Central Planning Authority

Agenda for a meeting of the Central Planning Authority to be held on March 04, 2020 at **10:00a.m.** in the Conference Room, 1st Floor, Government Administration Building, Elgin Avenue.

CPA/05/20

Figure 1. Site location and environmental context plan.

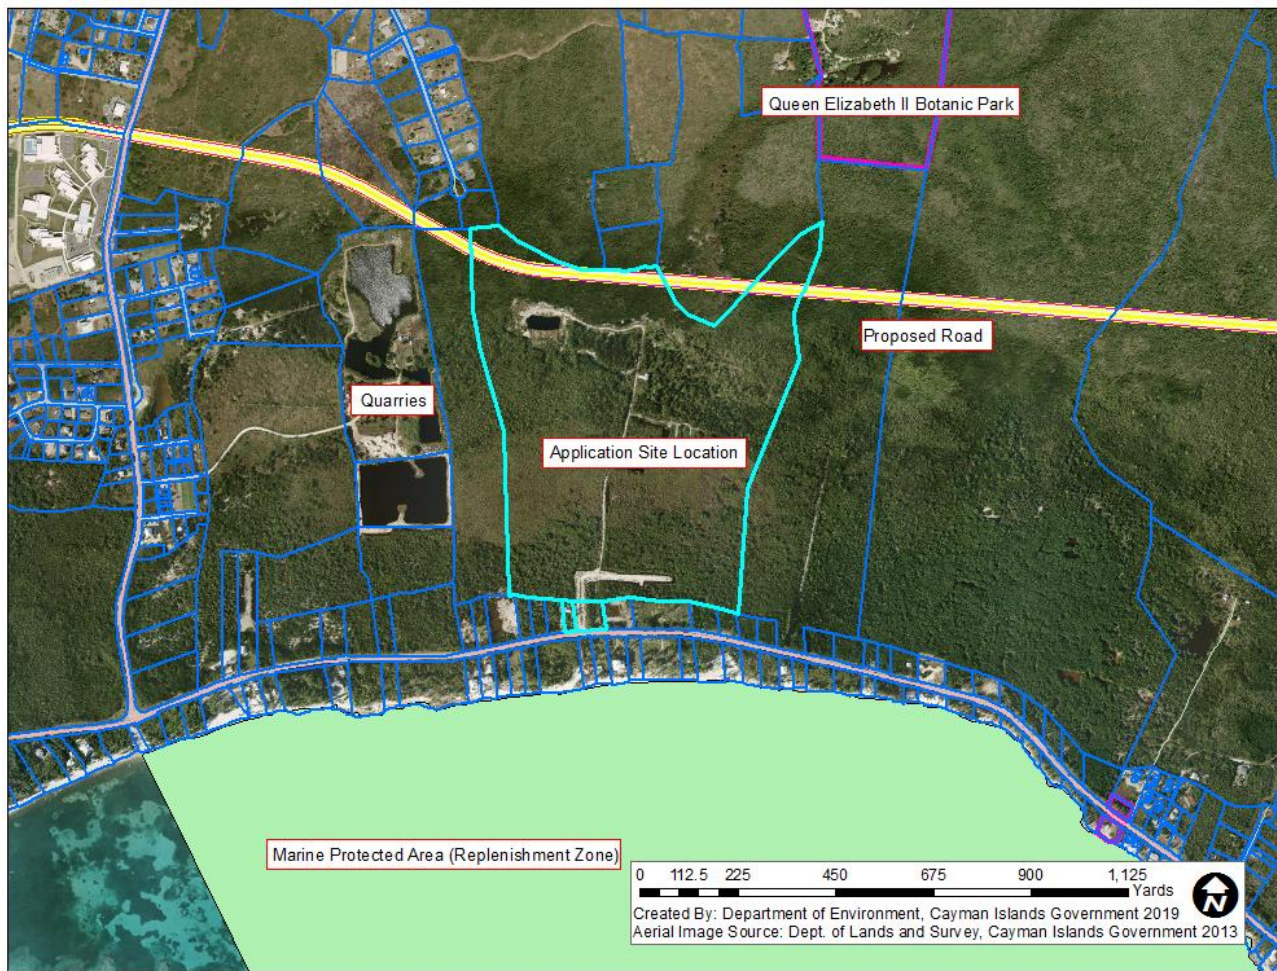
The site is located at Block 59A Parcels 60, 92 and 156, north of Sea View Road in East End. The site location is shown on Figure 1. The main parcel, Block 59A Parcel 92, has an area of 100 acres.

Figure 2. Habitats present at the site.

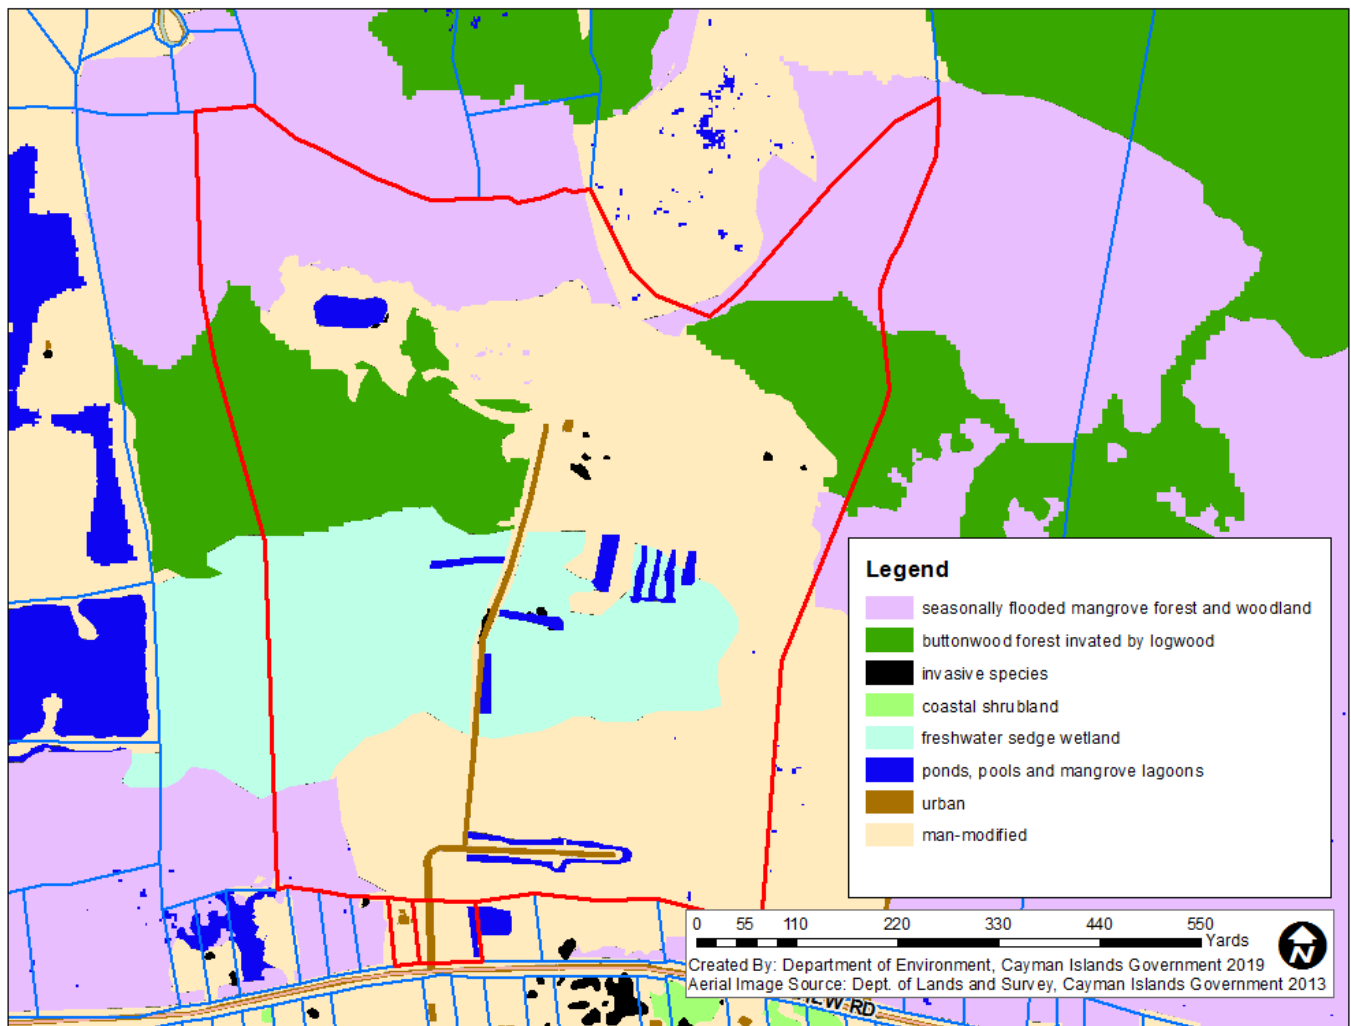
A site visit was undertaken on 20 March 2019. The majority of the site was man-modified. There was an area where the Buttonwood forest had been invaded by Logwood and therefore the ecological value was compromised. There was also an area (approximately 19.3 acres) of seasonally flooded mangrove forest and woodland, in the southern part of the site. The habitats at the site are shown in Table 1 and in Figure 2.

Figure 3. The topography of the site appears to indicate that the site is a water retention basin or drainage basin.

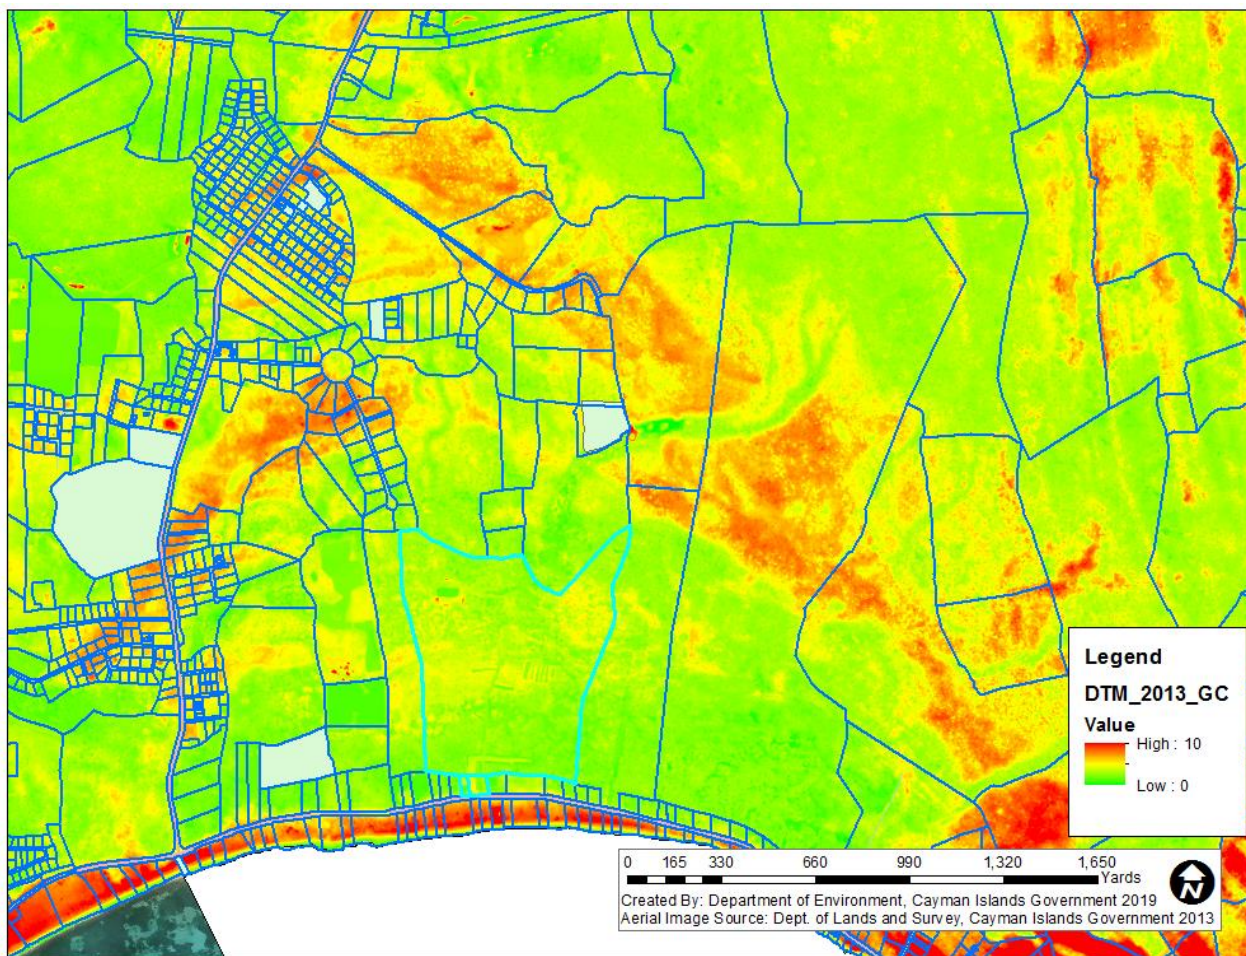
The site is low-lying and currently comprises areas which are seasonally flooded mangroves and a freshwater sedge wetland. During the site visit conducted on 13 March 2019, there was standing water visible across much of the site. The topography of the site and surrounding area shows that the site appears to be within a drainage basin. There is a ridge to the south of Sea View Road, and an area to the north of higher elevation (Figure 3).

Figure 4. Excavation of the proposed LPP within the site, reducing its value to the community.

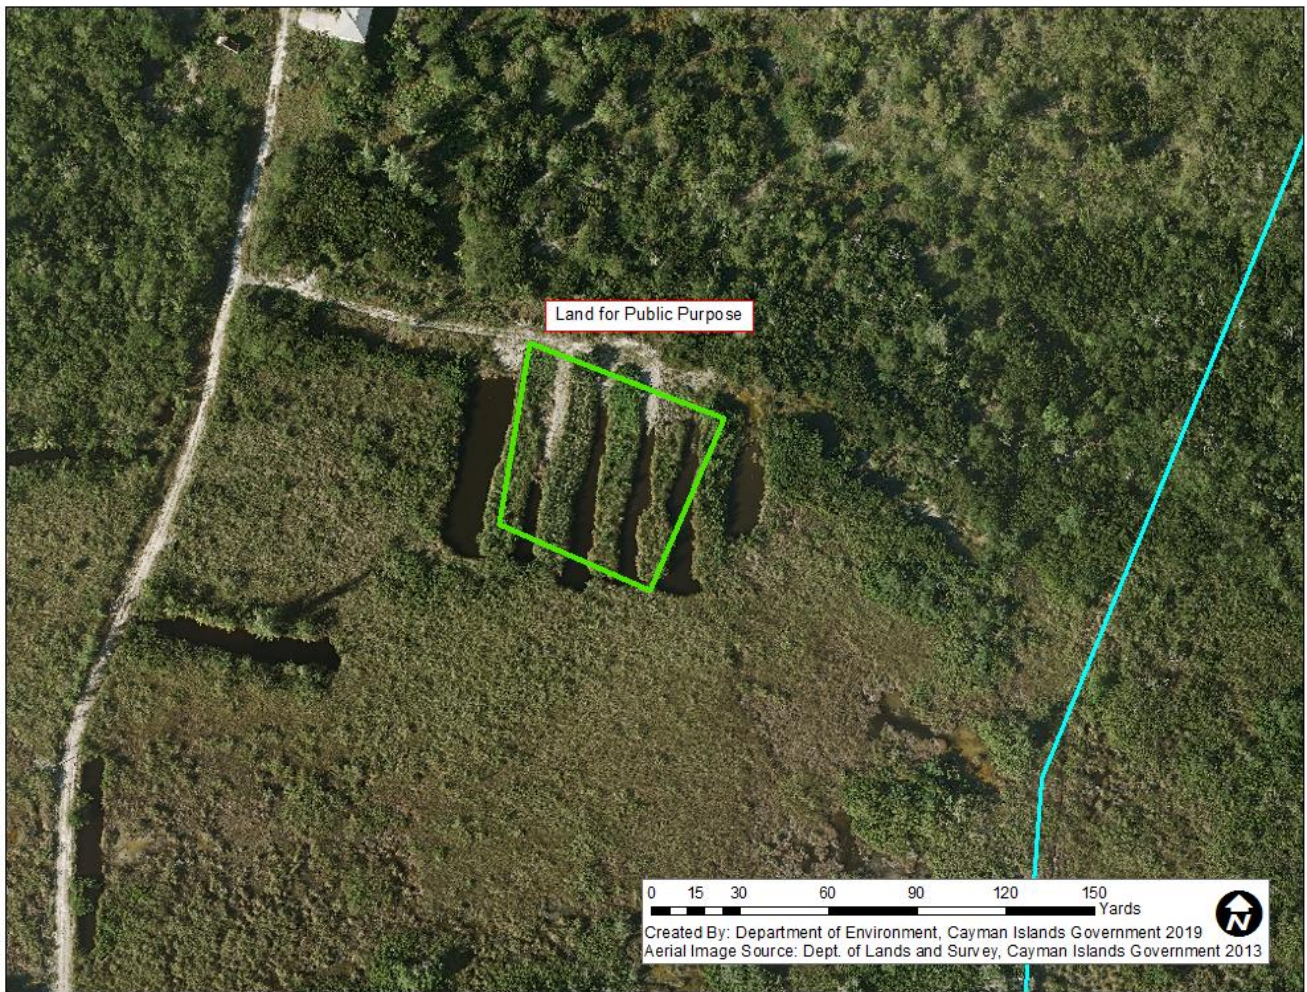
Furthermore, it is recommended that the LPP be located such that it provides value to the community.
